Access Compliance Report Public Rights-of-Way (Curb Ramps)

Intersection ID: 18084Main Street:E_WOODLAWN_RDCross Street:FAIRBLUFF_PLLocation:SWADA ID: 647E07CE7184Ramp Type:ParaInitial Pass/Fail:FailOverall Compliance:NoSeverity Score:26.25

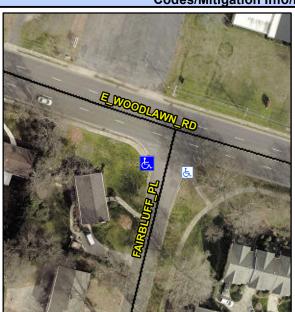
LT RP < 5%

PROW/ADA:

R304.5.3, R304.3.2

Possible Solutions:

Remove & Replace Entire Ramp.
